ADDENDUM NO. 1

April 14, 2022

YOST ELEMENTARY SCHOOL ADDITIONS AND RENOVATIONS Chesterton, IN 46304

Addendum One (AD.01) to the drawings and specifications prepared by Gibraltar Design for **New Yost Elementary School** for Duneland School Corporation, Chesterton, Indiana.

A-103

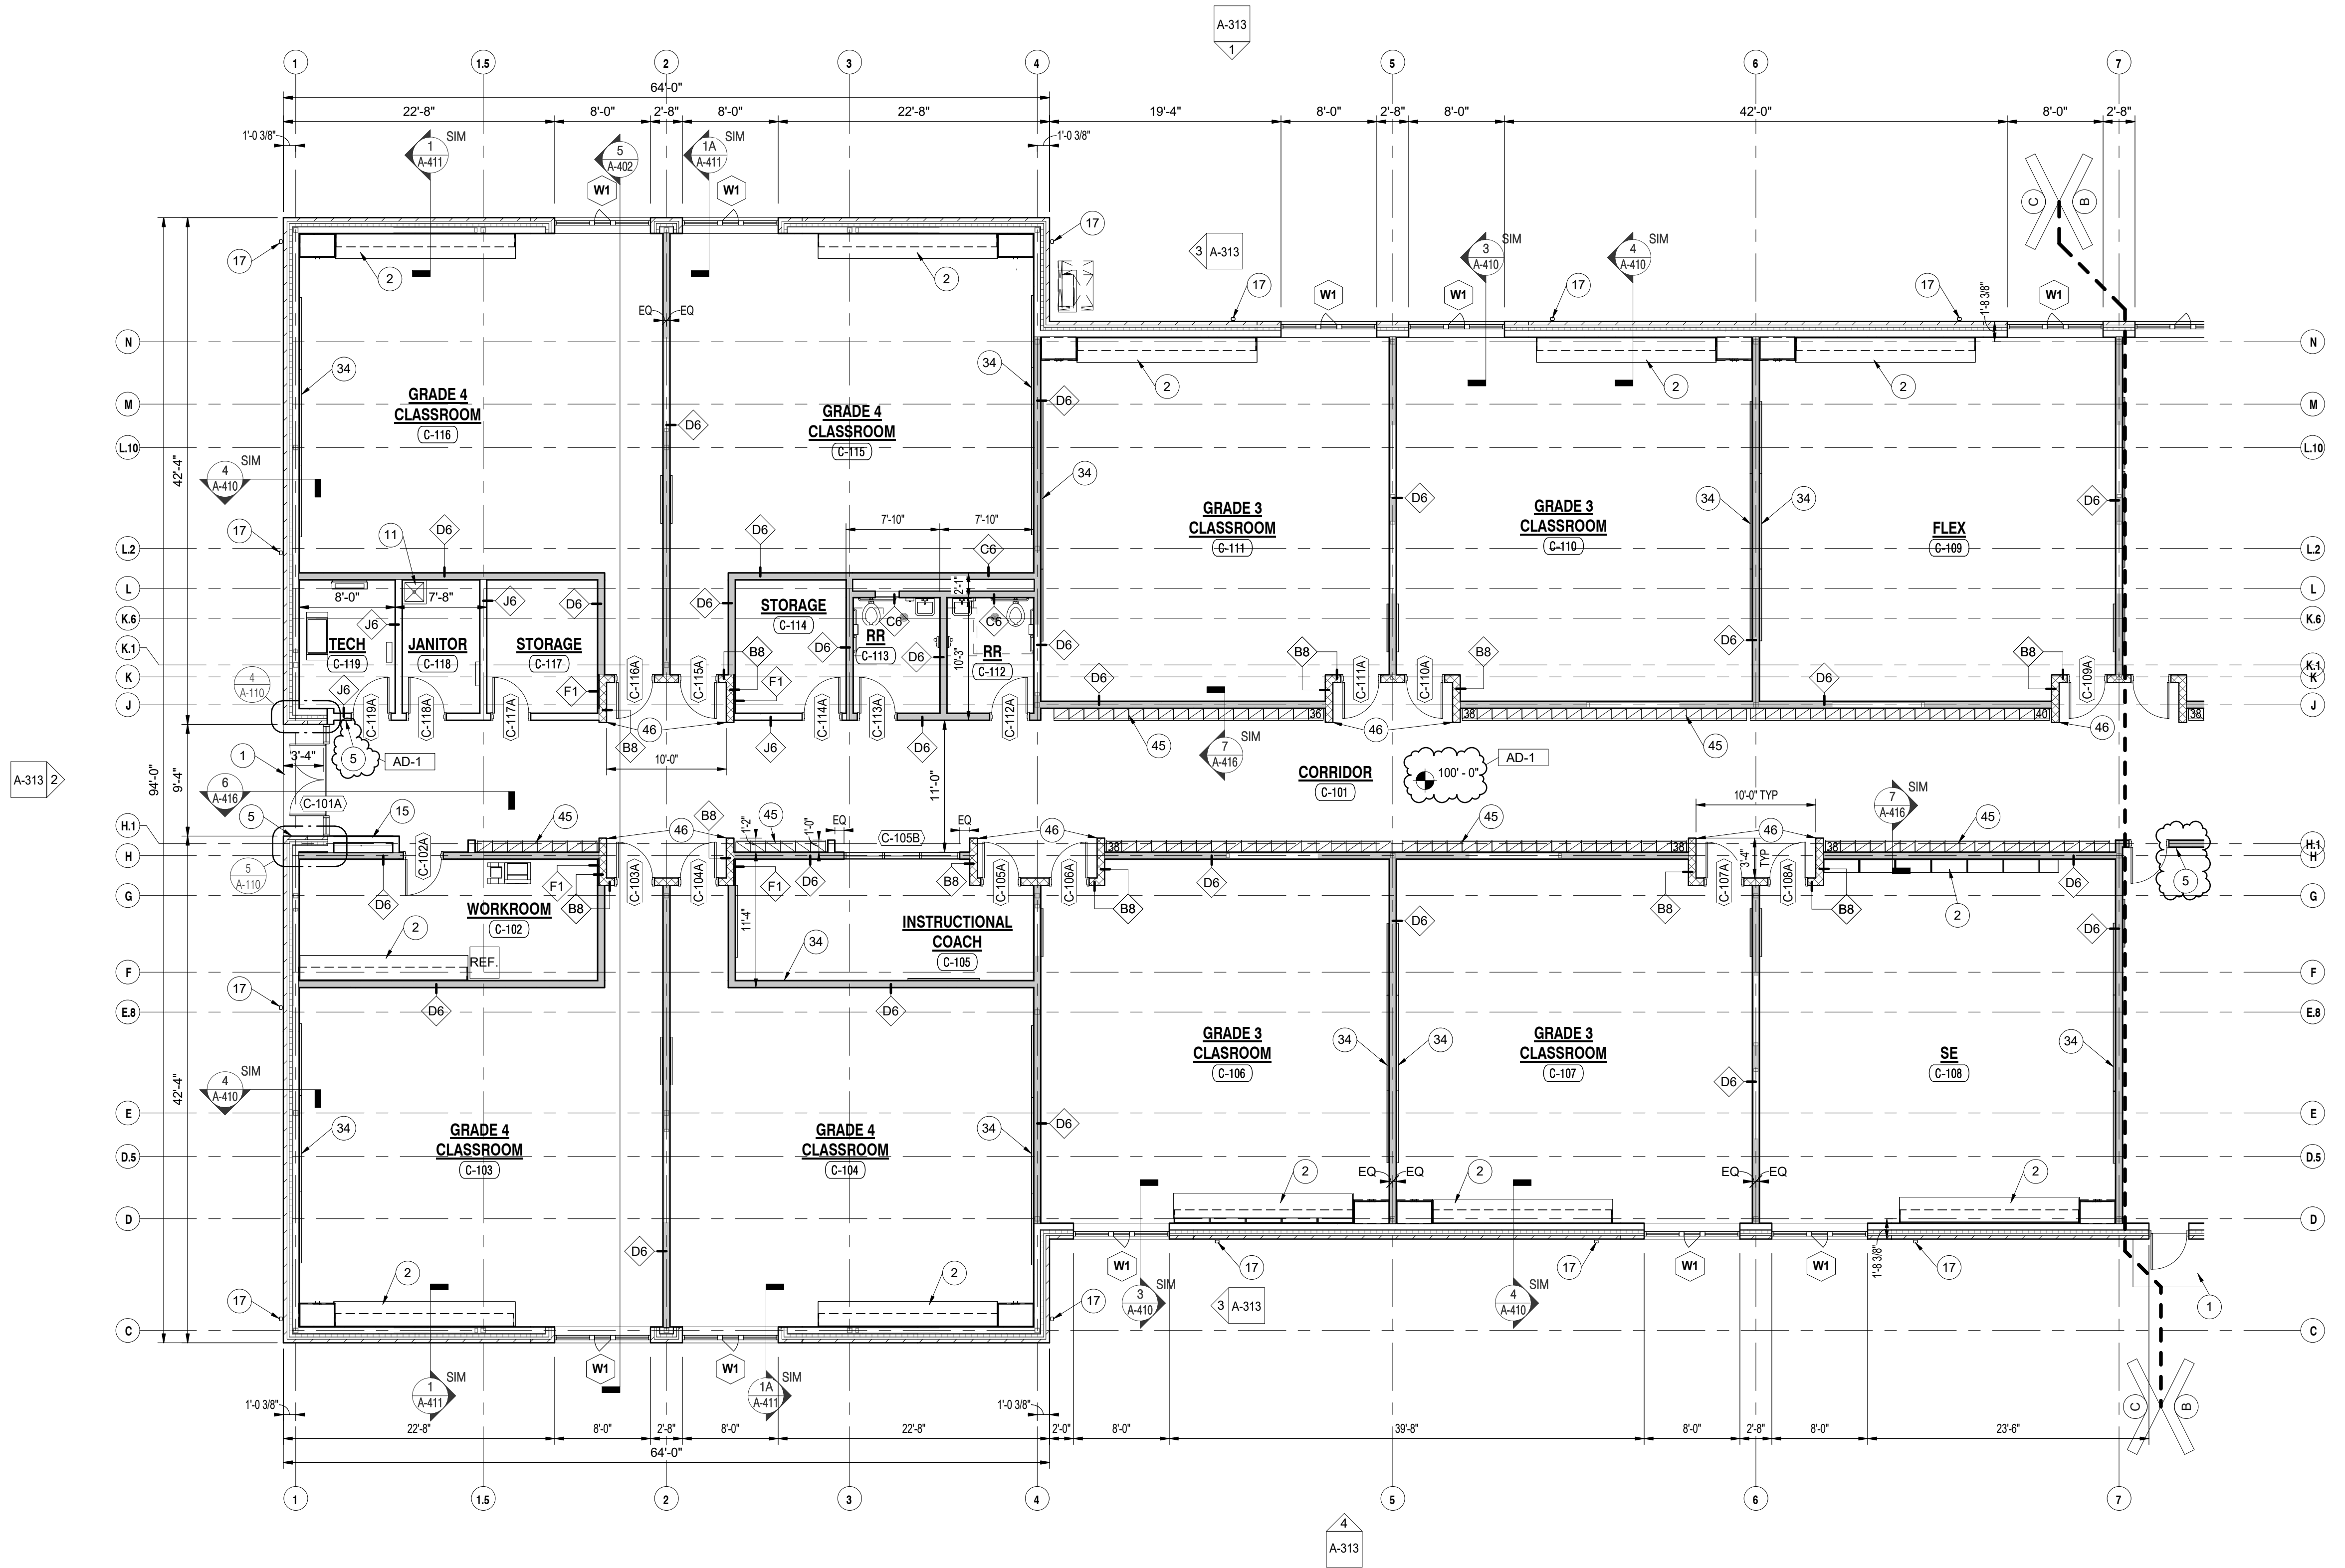
7. Sheet A-103

- A. Refer to revised full size drawing, included in this Addendum, for the following revisions:
1. Add Note 5 to Door C-119A.
 2. Add floor elevation to Corridor C-101.
 3. Add Note 2 to casework on north wall of SE C-108.
 4. Add floor elevation to Equipment Platform Unit B B-201.

A-104

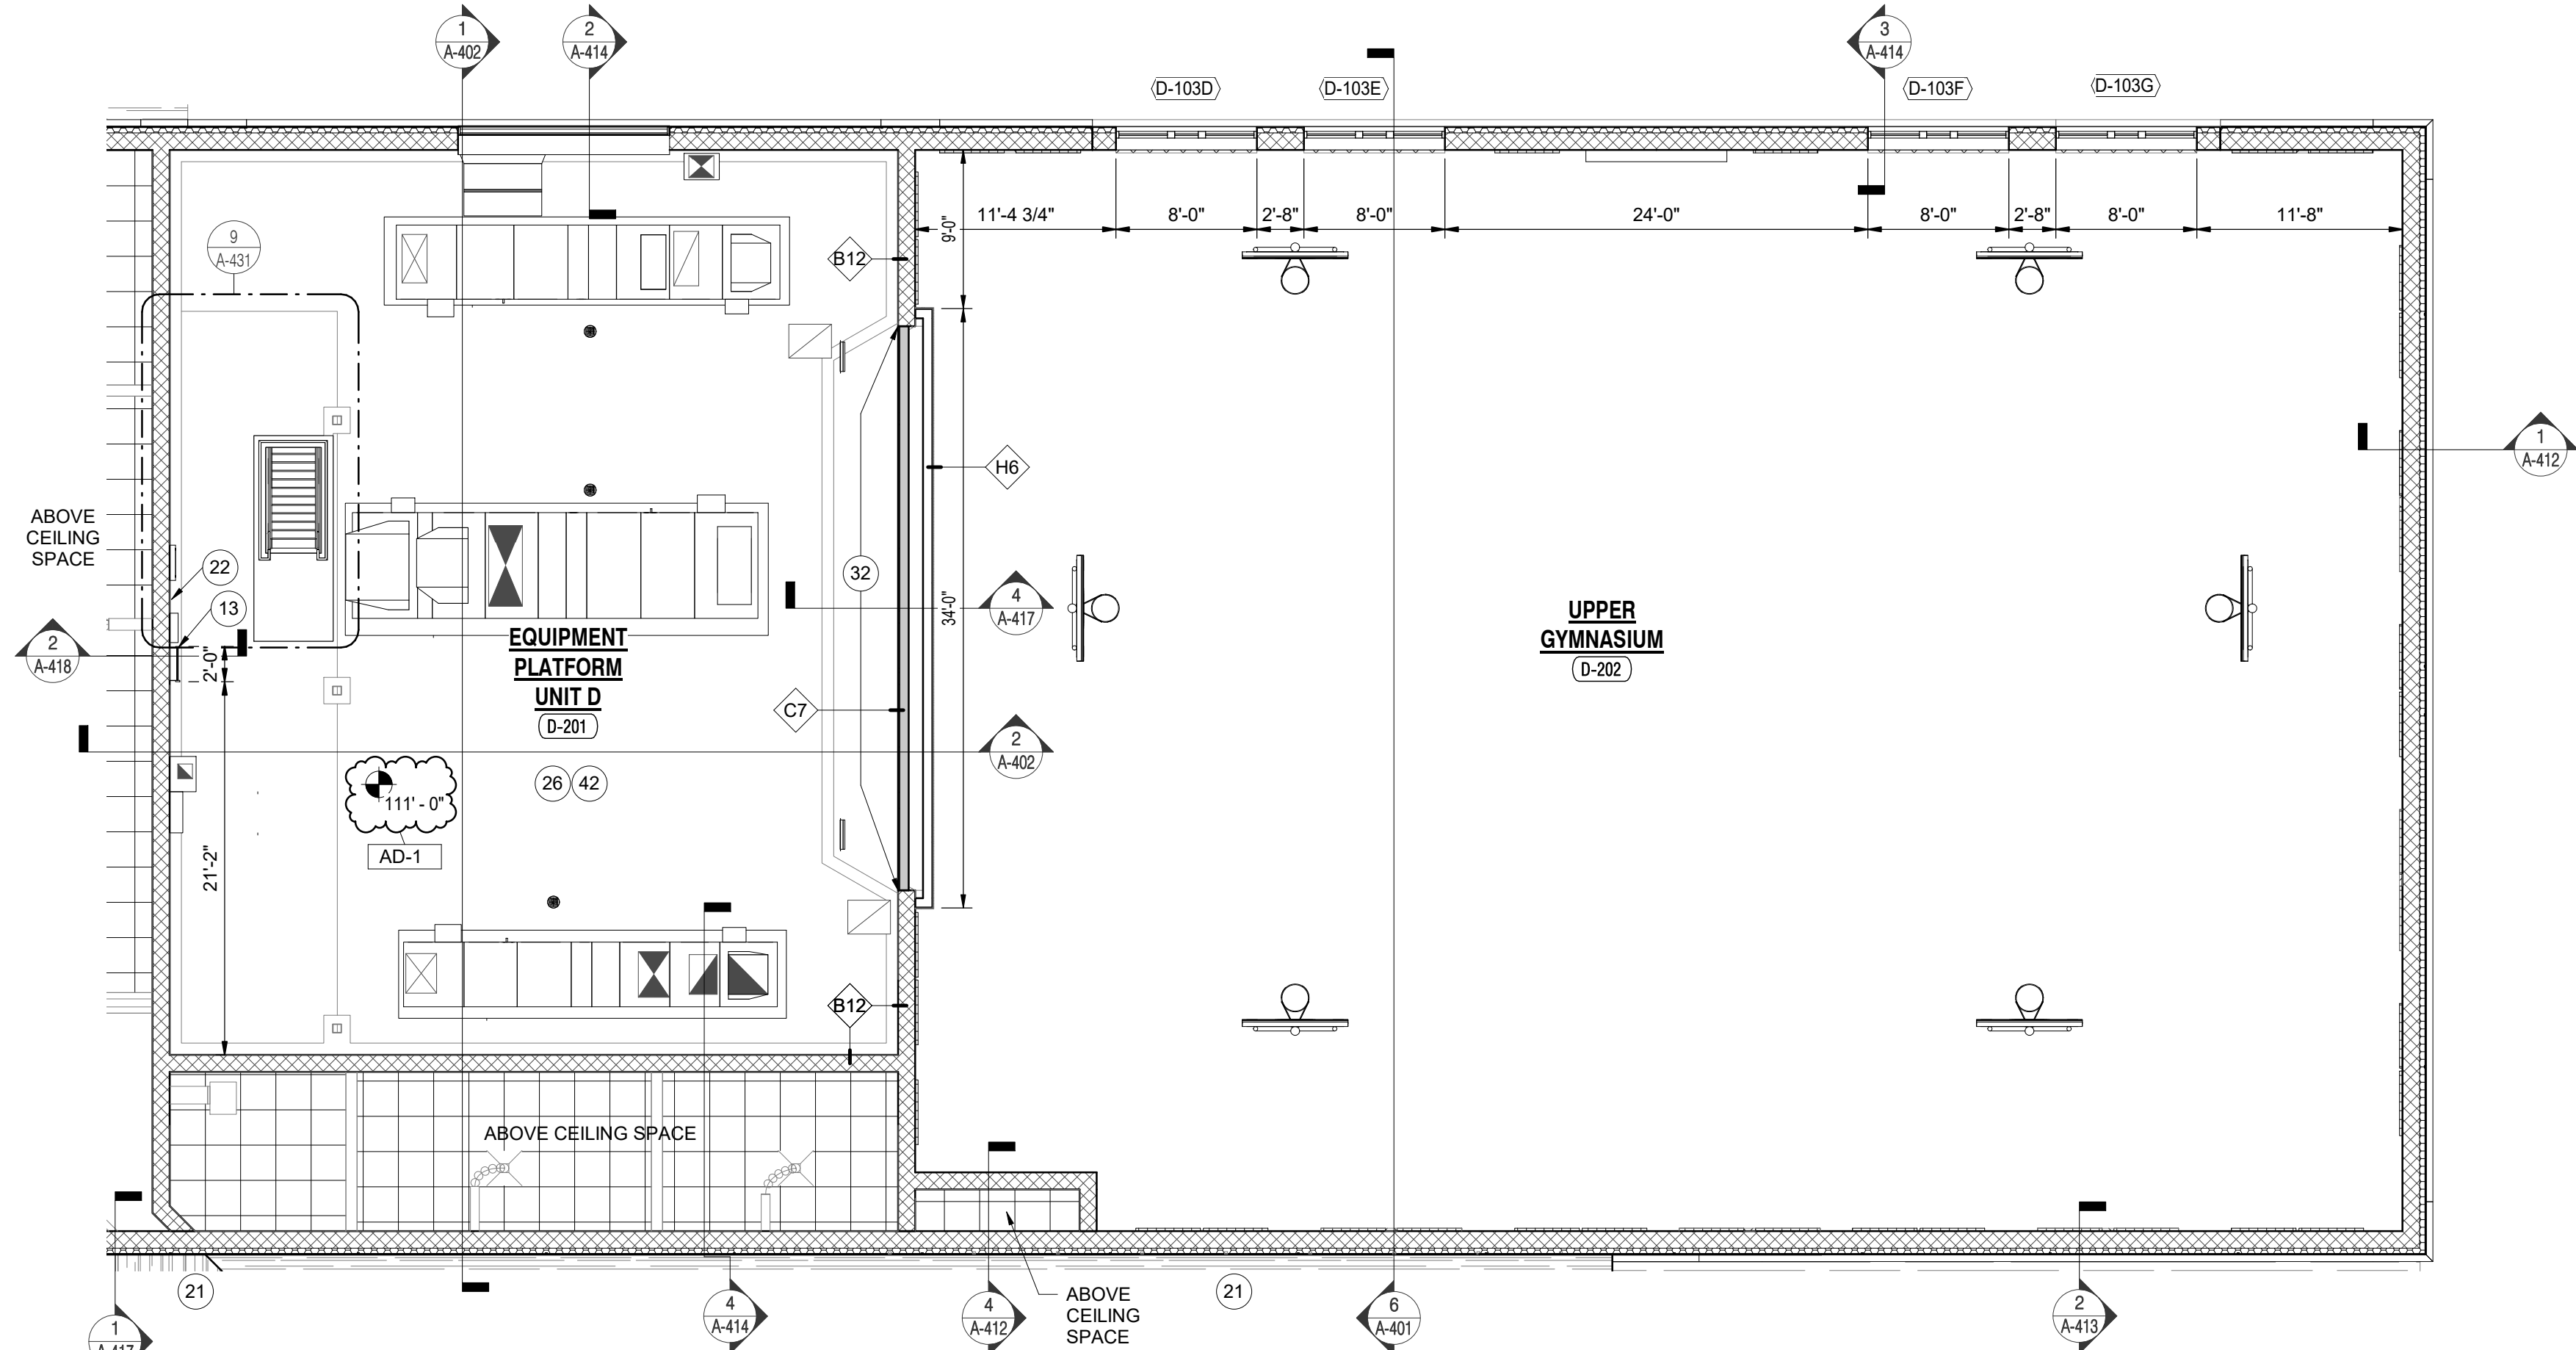
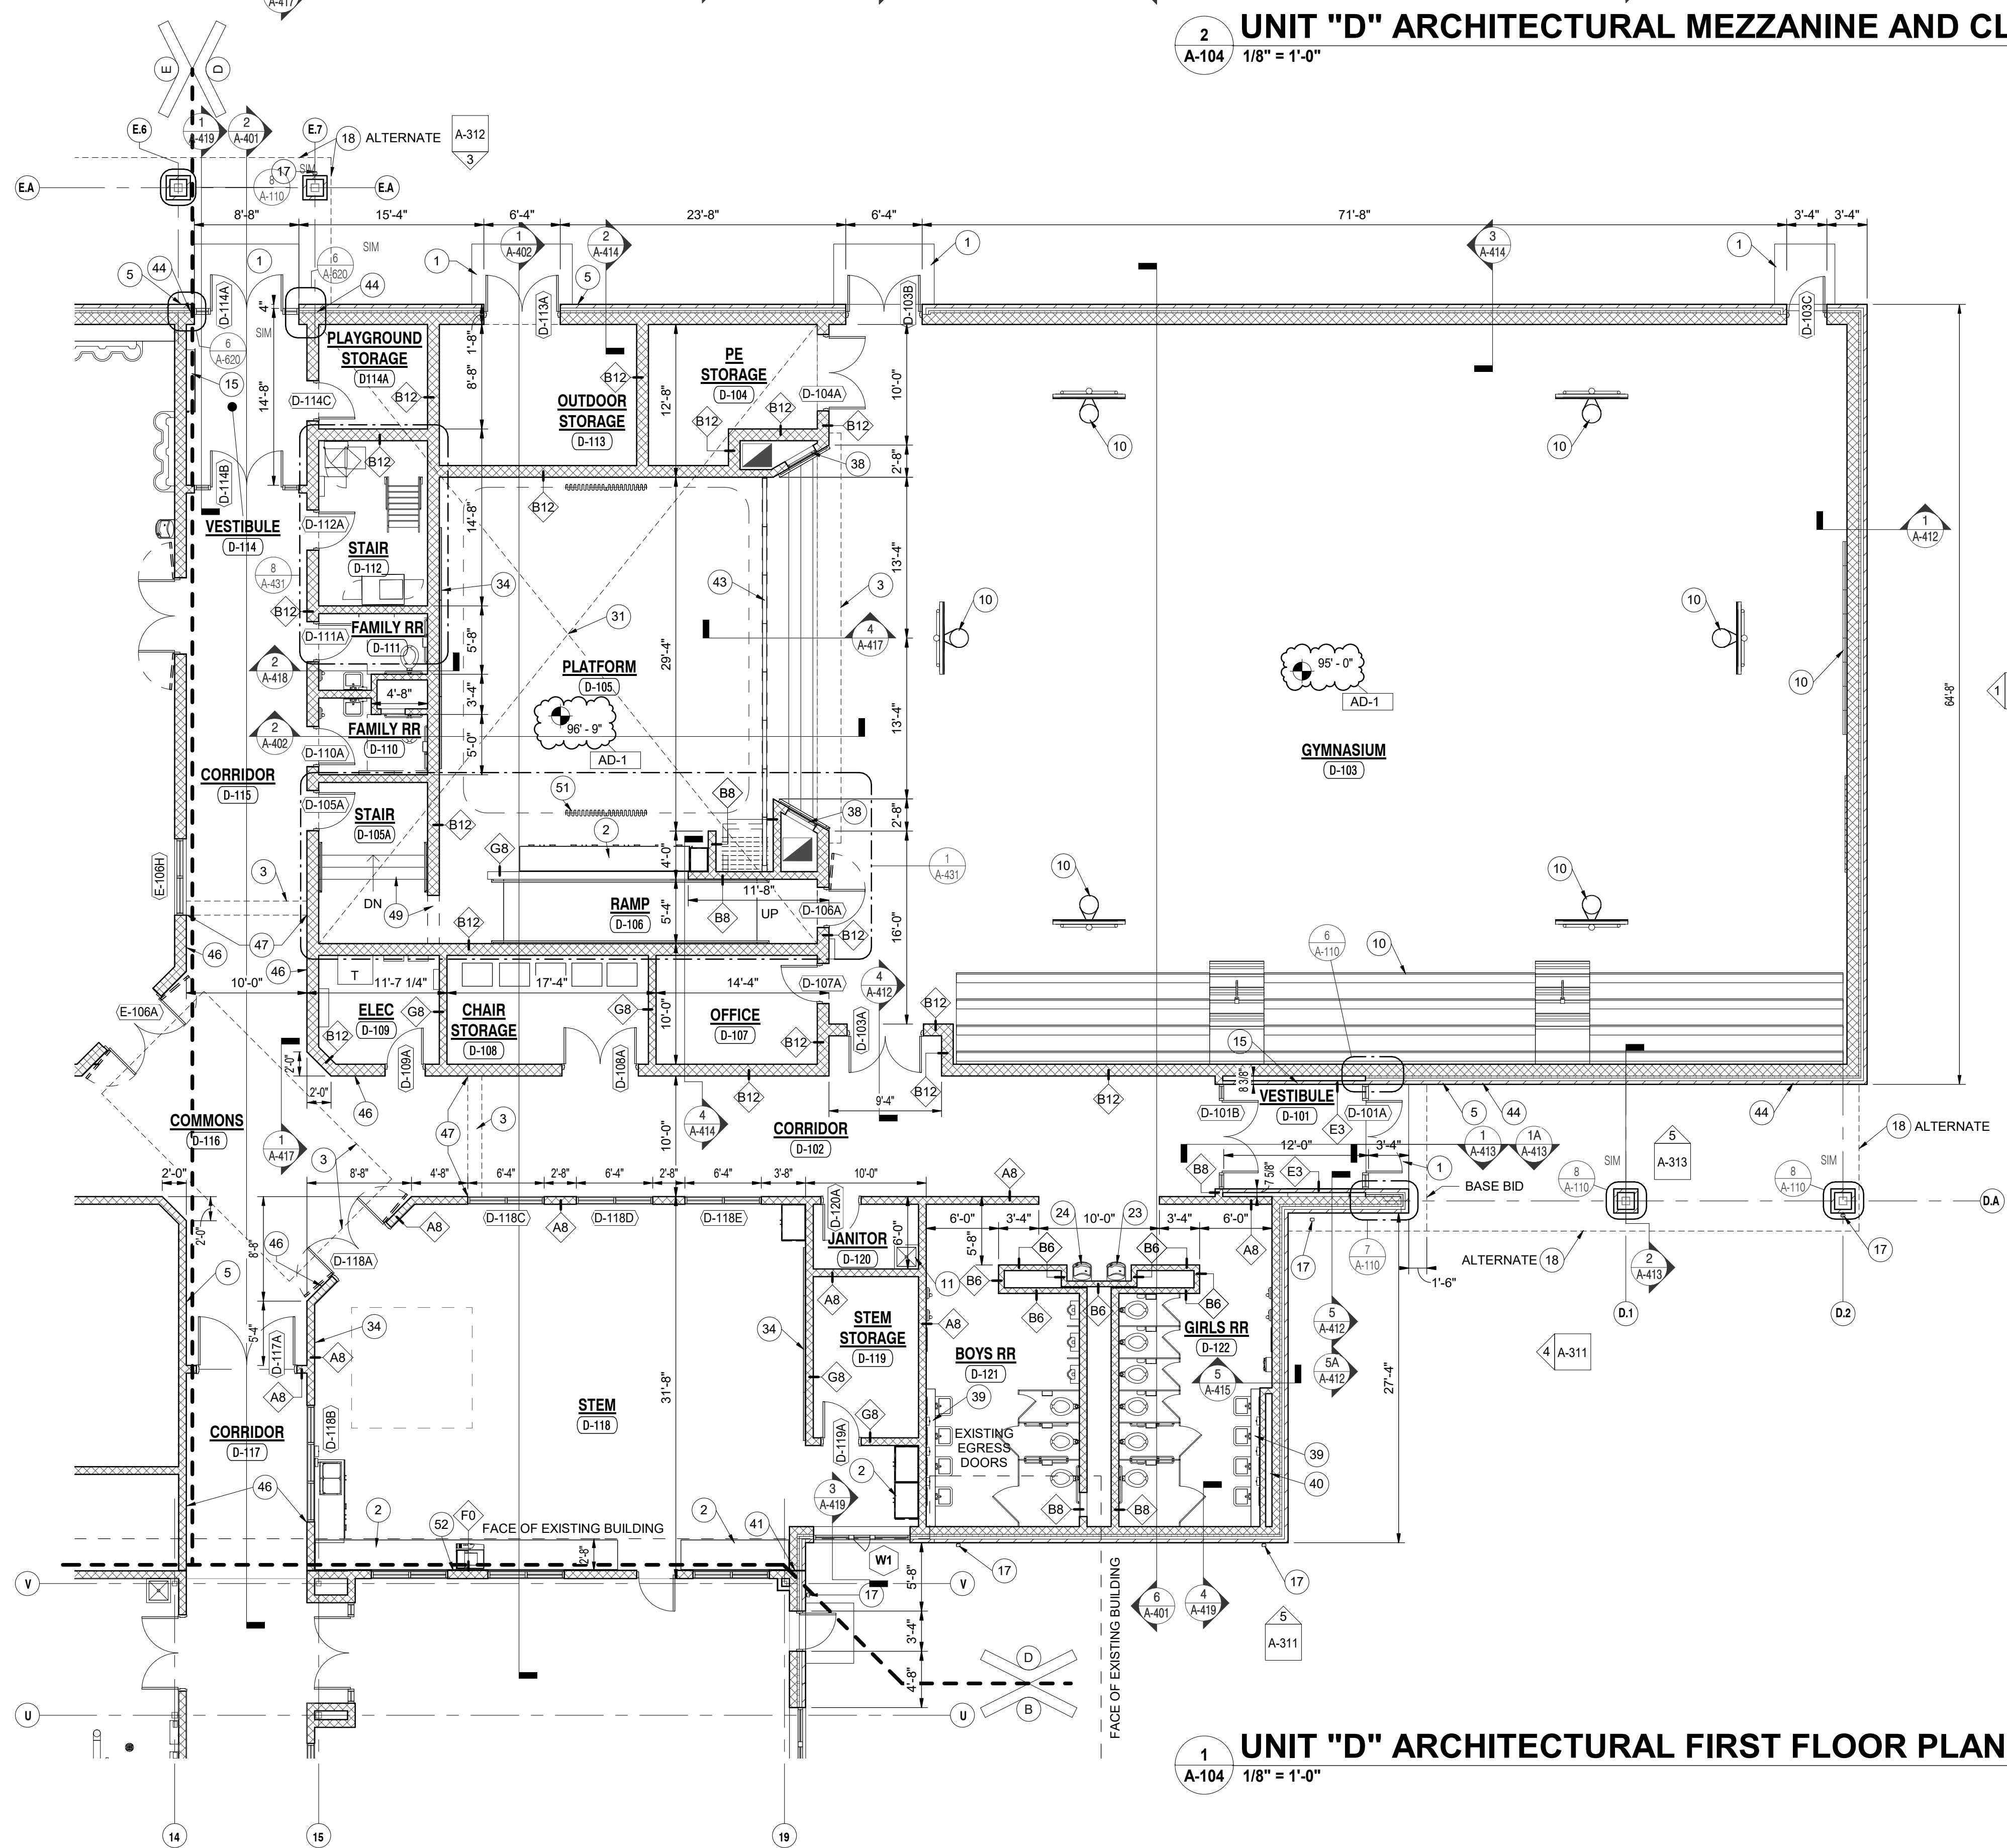
8. Sheet A-104

- A. Refer to revised full size drawing, included in this Addendum, for the following revisions:
1. Add floor elevation to Gymnasium D-103, Platform D-105, and Equipment Platform Unit D D-201.
